MADINA

Lot 80

ZANCOR
HOMES

Purchaser(s) Walter Young & Paul Roberts
Subdivision: King Ridge

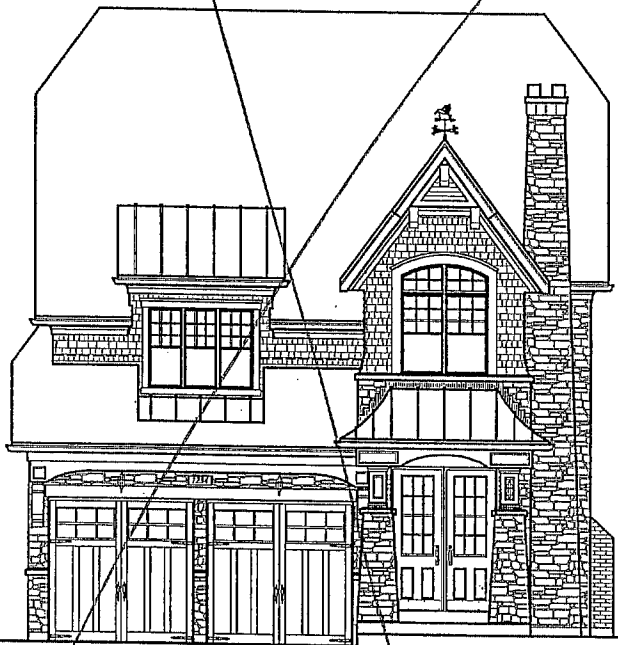
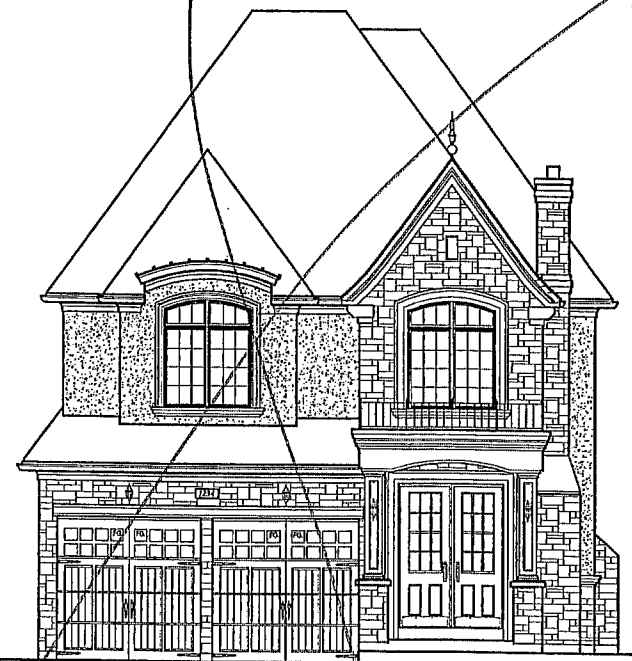
ID	Description	Invoice	Date Ordered	
7099	Bedroom 4 - take out closets by bathroom wall and move to other side of bedroom	1386		
7100	Main Bathroom - put door from bedroom 4 into main bathroom (door into toilet area may have to be removed)	1386
